## MEMORANDUM

May 7<sup>th</sup>, 2014

**SUBJECT:** Public hearing and consideration of a Landmark Alteration Certificate to construct a free-standing 355 sq. ft. building to provide American with Disabilities Act-compliant restrooms immediately west of the Chautauqua Auditorium at 900 Baseline Rd., in the Chautauqua Park Historic District, per section 9-11-18 of the Boulder Revised Code (HIS2014-00089).

Figure 6. Site Plan Showing Proposed Location of the Restroom Building

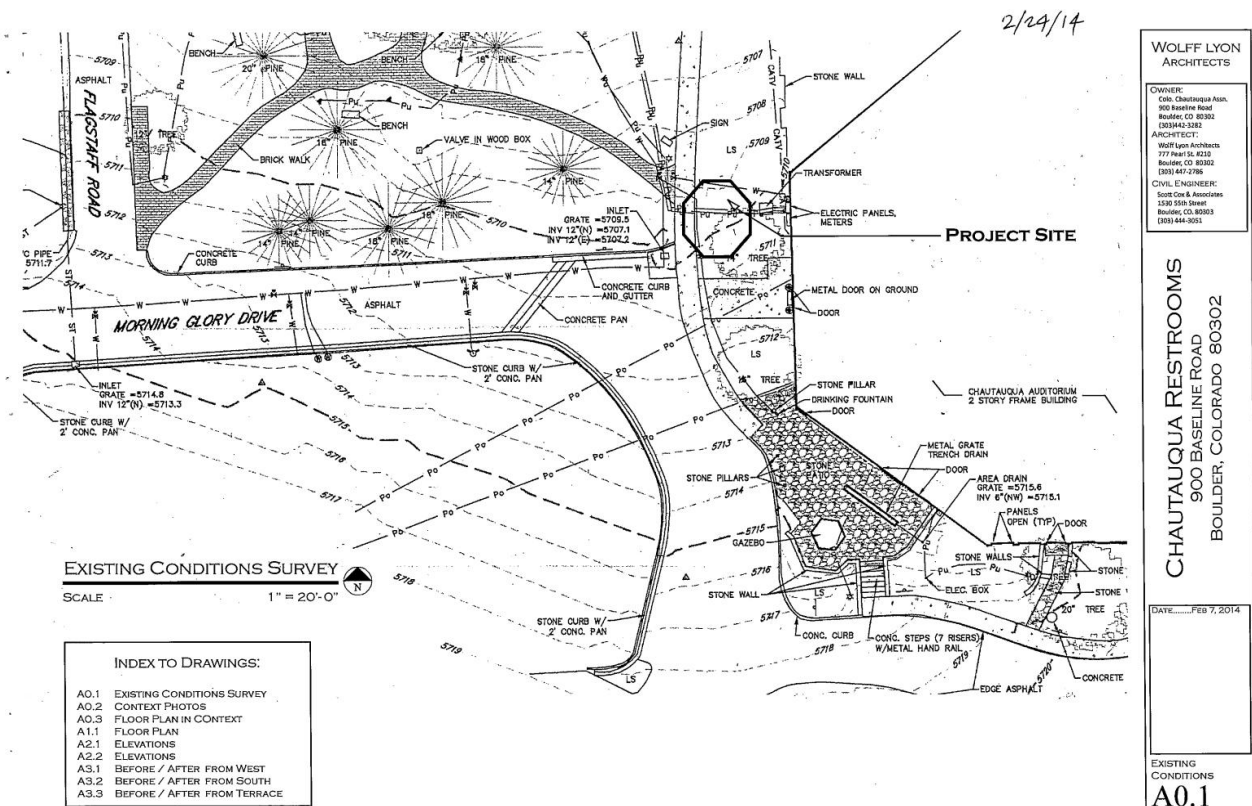
The proposed location is north of an existing service entrance, and adjacent to a pedestrian path that connects the Auditorium to the Dining Hall. The proposed location would require the removal of a mature tree.

Figure 8. Proposed South Elevation

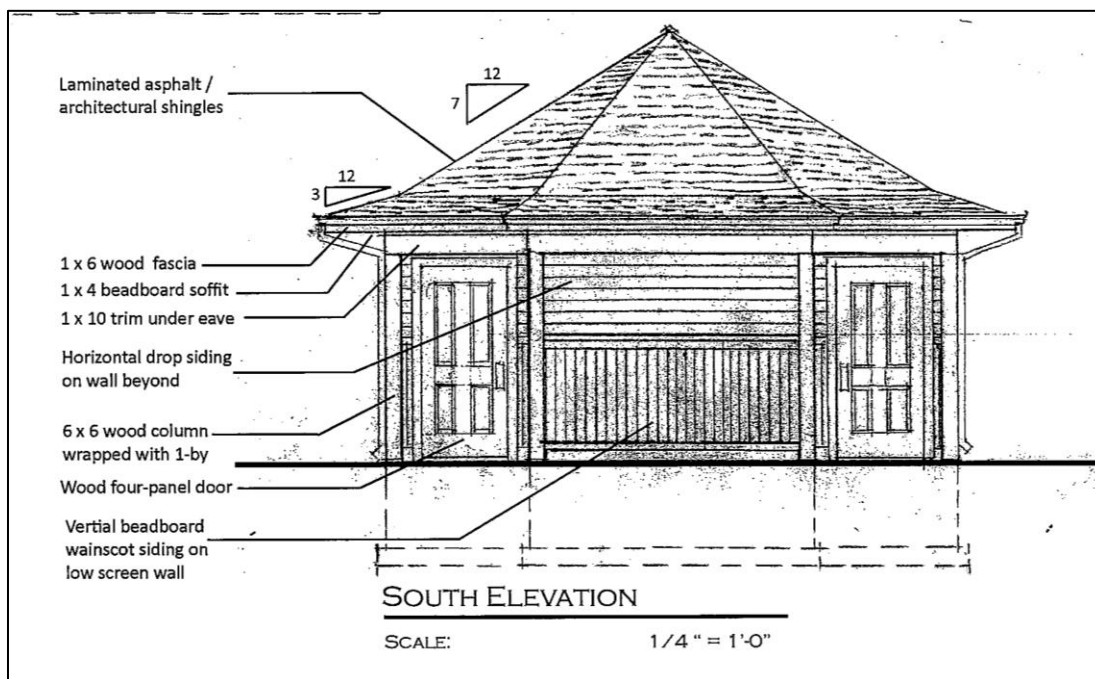
The south roof area of the building extends over the wall, sheltering a low entrance. A low screen is proposed between the two simple column supports. Two, four paneled wooden doors are also located on this elevation.

2. Prior to submitting a building permit application and receiving final issuance of the Landmark Alteration Certificate, the applicant shall submit revised plans for the proposed restroom facilities showing a reduction in height in a manner consistent with *General Design Guidelines for Boulder's Historic Districts and Individual Landmarks* and the *Chautauqua Park Design Guidelines*.

Figure 9. Proposed West Elevation

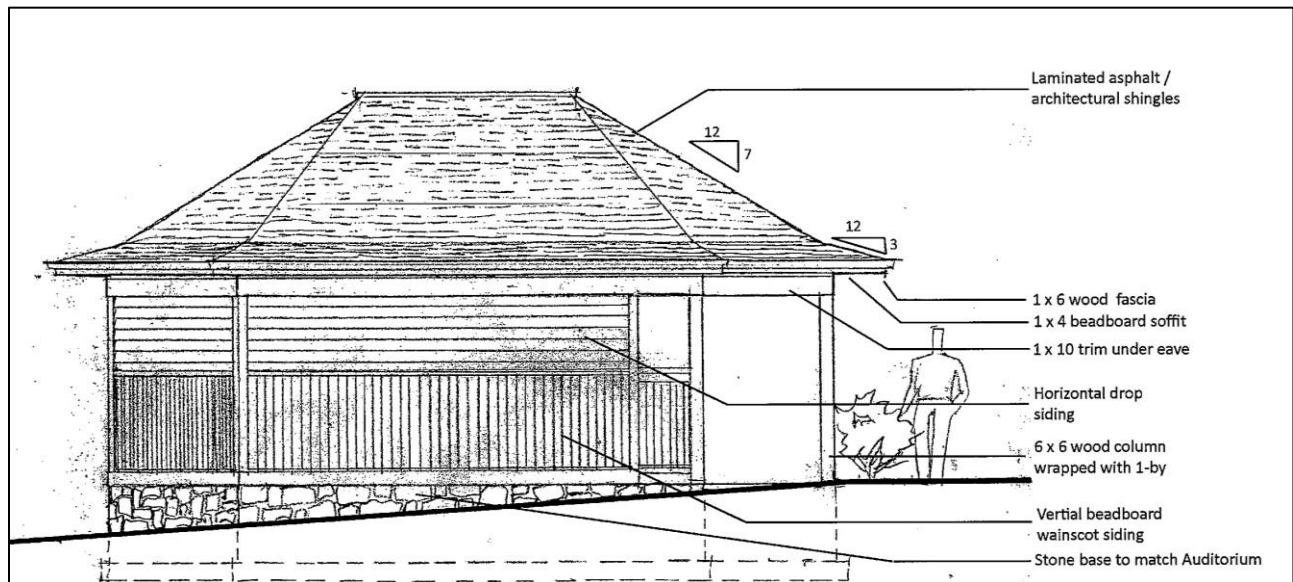
The proposed west, east and north elevations are show to be clad in vertical bead board on the lower portion of the building and horizontal drop siding above.
